*Amendments to the Drawings*

Application No.: 10/722,466  
Art Unit 1746

Attorney Docket No. 0465-1103P  
Reply to September 27, 2006 Office Action  
Page 14

**FIG. 1**  
**Prior Art**

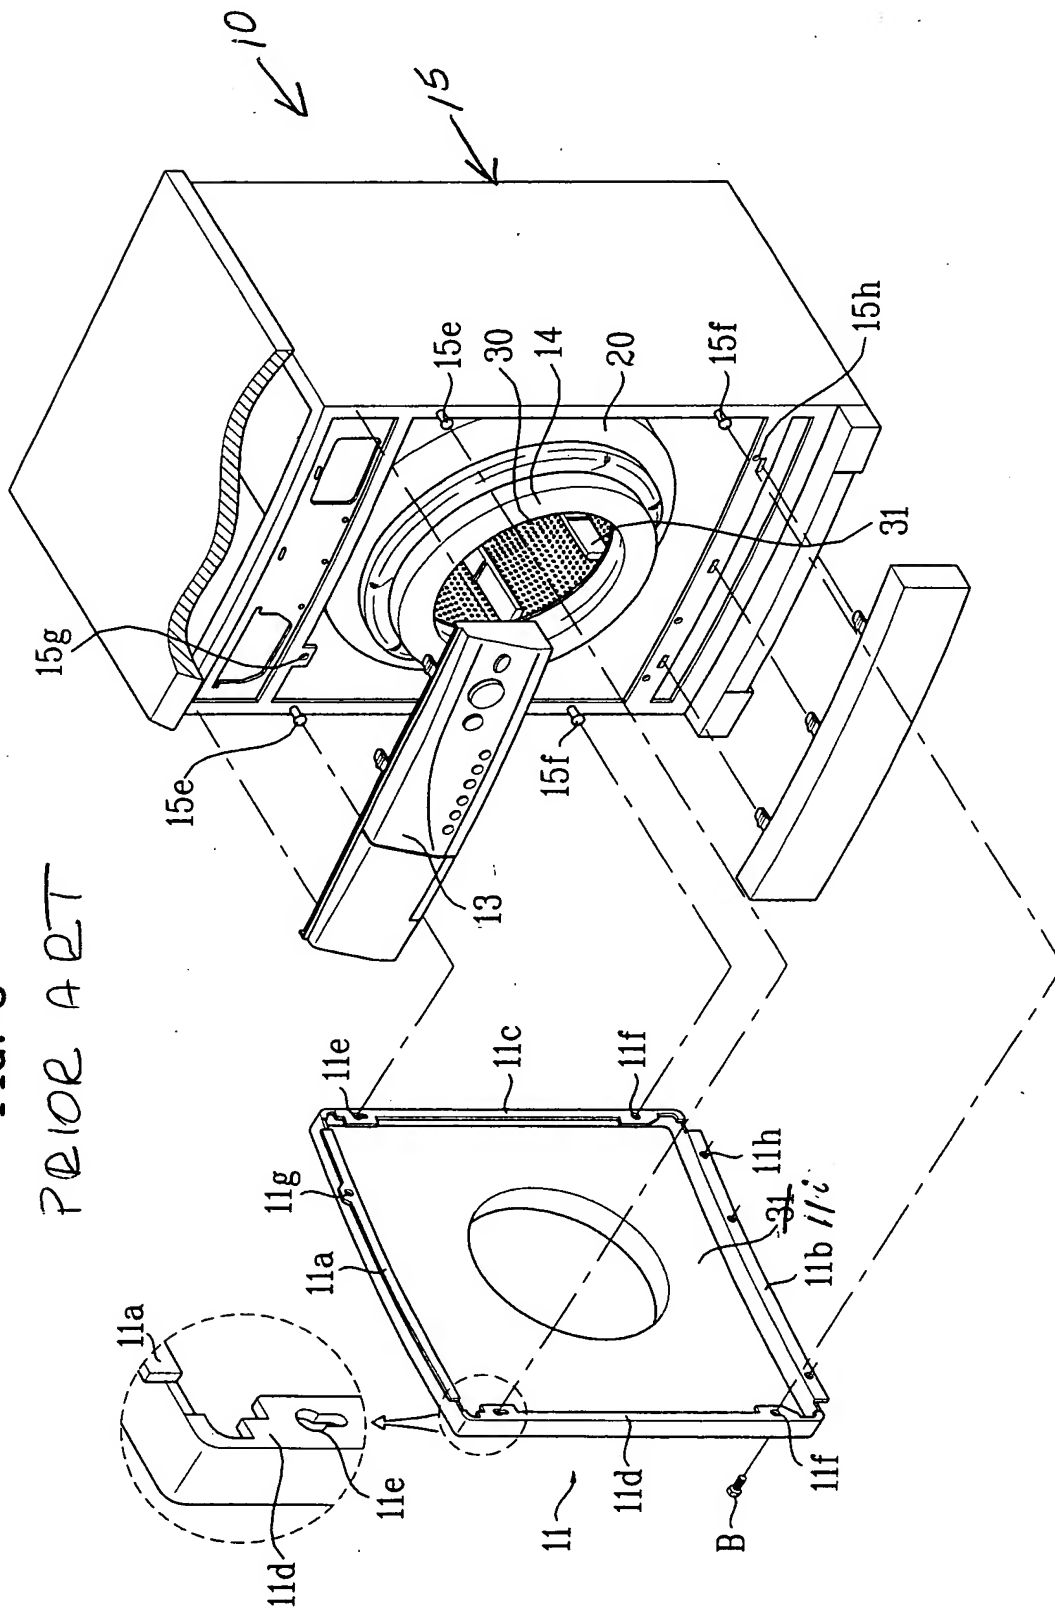
Figs. 1-3 are amended to include the legend - - Prior Art - -.

The Examiner has objected to the drawings because the drawing figures contains some labels that are not disclosed in the specification and do not show all labels disclosed in the specification, and because Figs. 1-3 are not labeled as prior art. This objection is respectfully traversed.

With respect to the suggestion to label Figs. 1-3 as "Prior Art," Applicants have labeled Figs. 1-3 as "Prior Art." Applicants submit that the drawing corrections filed herewith, which include the label "Prior Art", meet the criteria of MPEP § 608.02(g). Accordingly, reconsideration and withdrawal of this objection, and approval of the drawing corrections filed herewith, are

**FIG. 3**

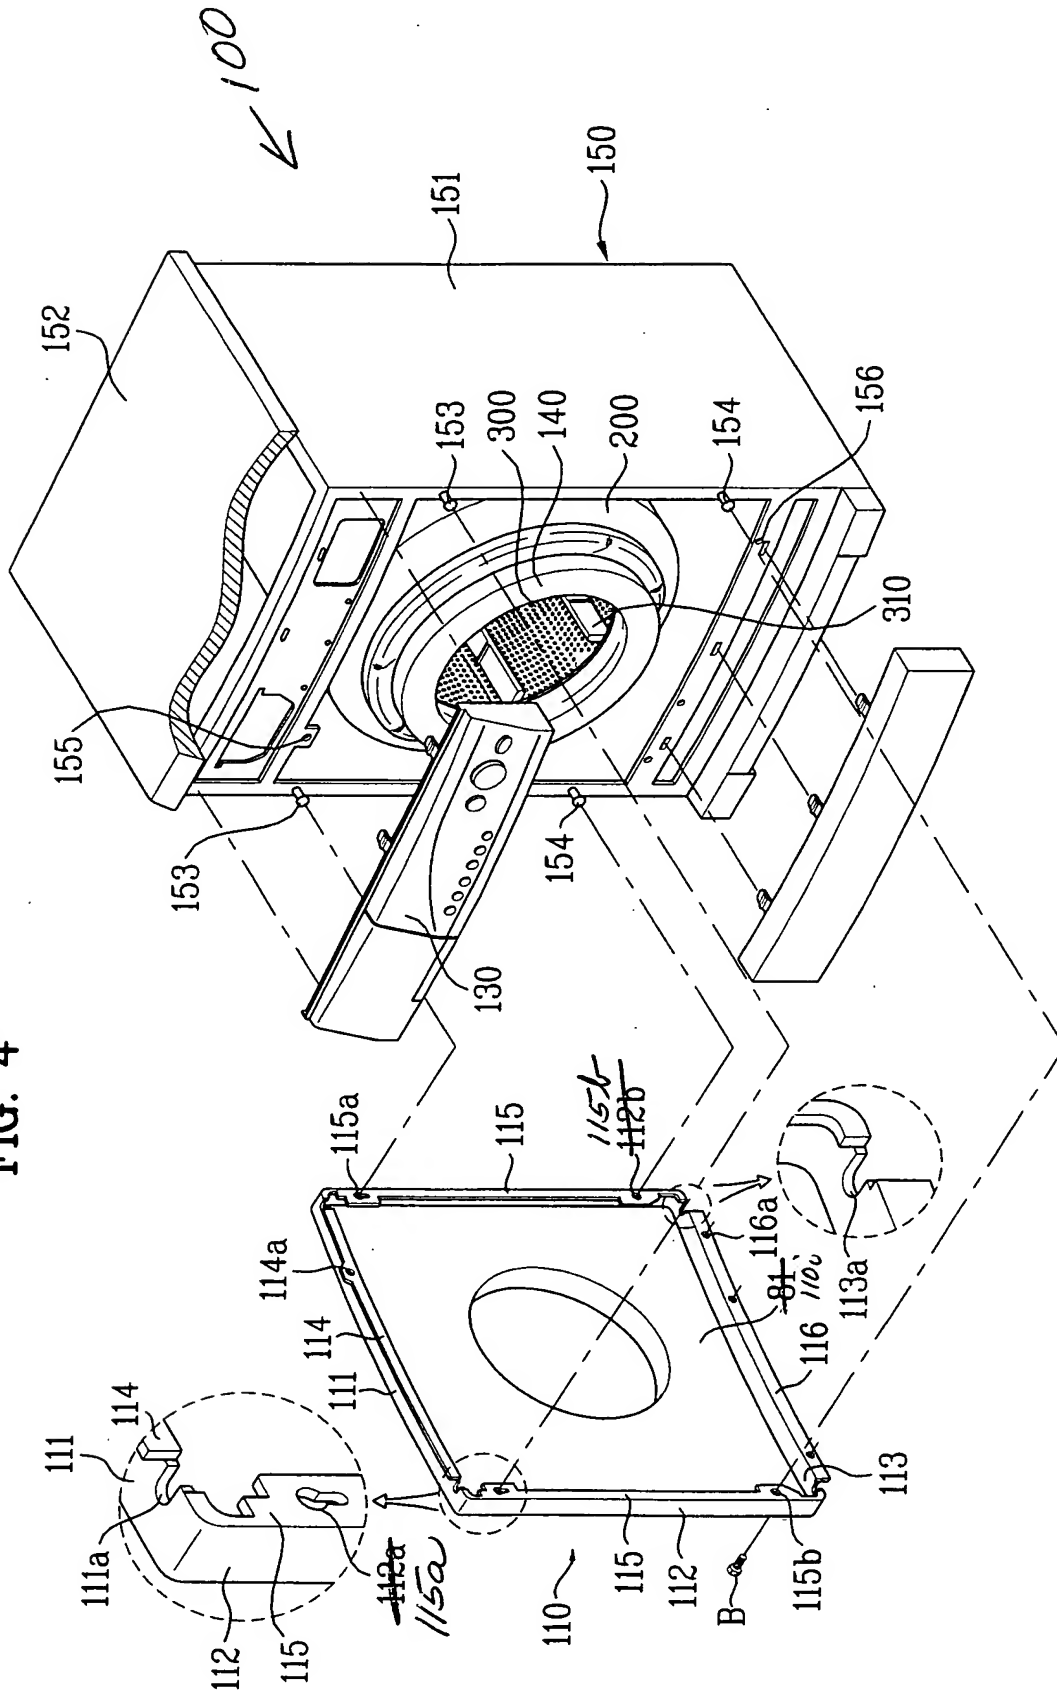
Fig. 3 is also amended by adding label numerals - - 10 - - and - - 15 - -, and by changing “31” to - - 11i - -.

Applicants thank the Examiner for the thorough review of the specification and drawings. Applicants have also further reviewed the specification and drawings with the Examiner's observations in mind, and are amending both the specification and drawings to make the specification and drawings consistent. Based on this further review, Applicants have determined that Fig. 3 labels two different elements with the same reference numeral, i.e., "31." To correct this informality, Applicants have replaced one instance of "31" with number "11i" in Fig. 3.

Applicants have also amended Fig. 3 by adding labels "10" and "15" based on the informalities noted by the Examiner.

Fig. 4 is amended by changing “112a” to - - 115a - -; by changing “112b” to - - 115b - -; by adding - - 100 - -; and by changing “81” to - - 110i - -.

Applicants also respectfully submit that Fig. 4 does actually show tub 200 labeled as such, contrary to the assertion that element 200 is not shown in any drawing figure.

Applicants have also amended Fig. 4 by replacing "112a" with - - 115a - - and by replacing "112b" with - - 115b - -; and by adding cabinet label number 100. Also, to be consistent with the new label "11i" in Fig. 3, Applicants have replaced numeral "81" in Fig. 4 with - - 110i - -.
